NVM Express® Technical Proposal for New Feature

Technical Proposal ID	6033 - MCTP Packet Timing
Change Date	2023.04.27
Builds on Specification	NVM Express® Management Interface 1.2b
References	TP6021 Status Reporting Enhancements TP6027 Reset Behavior Clarifications

This Technical Proposal clarifies and expands packetization constraints for NVMe-MI traffic over MCTP. This should create more consistent implementations across vendors and enable simpler Management Controller error checking and recovery. In addition, the Pause flag was simplified to one per Endpoint, the Abort primitive was cleaned up, and defined behavior for receiving new messages on a non-idle slot.

Figure 33: Command Servicing State Diagram

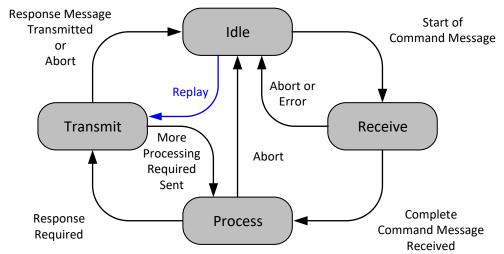
If a Command Slot that is not in the Idle state receives the start of a new Command Message, then:

- the Management Endpoint shall set the CMNICS bit to '1' (refer to Figure 42); and
- perform an implicit Abort Control Primitive (refer to section 4.2.1.3) with the exception that the Management Endpoint shall not transmit the Abort Control Primitive Response Message. If command servicing is:
 - o unable to be aborted, then the Management Endpoint shall:
 - respond with an Unable To Abort Error Response;
 - silently discard the new Command Message; and
 - continue servicing the Command Message being serviced at the time the new Command Message was received;

aborted, then the Management Endpoint shall proceed with servicing the new Command Message.

Idle: A Command Slot is idle when it is not in the Receive, Process, or Transmit state. This is the initial state of the command servicing state machine following a Management Endpoint Reset (refer to section 8.3.3). Command servicing transitions from the Idle state to the Receive state when the first MCTP packet of a Command Message is received (i.e., an MCTP packet with the SOM bit in the MCTP packet header set to '1' and the Message Type set to 4h).

If a Replay Control Primitive is received and there is a Response Message available for retransmission, then command servicing shall transition to Transmit state (refer to section 4.2.1.5).

Receive: The state when the first packet of a Command Message has been received and the Command Message is being received, assembled, or validated. Command servicing transitions from Receive to the Idle state when:

- an Abort Control Primitive is received successful;
- an error is detected in message assembly (refer to section 3.2.1.1); or
- the Message Integrity Check fails (refer to section 3.1.1.1).

Command servicing transitions from Receive state to the Process state when a Command Message is assembled and the message integrity check is successful.

Process: The state when a Command Message is processed. Processing of a Command Message consists of checking for errors with the Command Message and performing the actions specified by the Command Message or aborting the Command Message. Command servicing transitions from Process to the Transmit state when a Response Message is required to be sent. This occurs when the (i.e., processing of the Command Message has completed or command processing is expected to exceed the maximum Request-To-Response Time the corresponding MCTP transport binding specification response timeout (refer to section 4.2.2.1). Command servicing transitions from the Process state to the Idle state due to an Abort Control Primitive unless the Command Message could not be aborted (refer to section 4.2.1.3).

Transmit: The state in which a Response Message for the Command Message is transmitted to the Management Controller. Command servicing transitions from the Transmit to the Idle state once the entire NVMe-MI Response Message associated with the response to the Command Message has been transmitted on the physical medium or due to an Abort Control Primitive (refer to section 4.2.1.3). Command servicing transitions from the Transmit to the Process state after transmitting a More Processing Required Response Message.

If, and only if, both the command servicing did not complete in the Process state and the Command Slot is not paused, then the Management Endpoint transmits a Response Message with status More Processing Required. If the Command Message requires more processing, then the Command Slot shall transition back to the Process state.
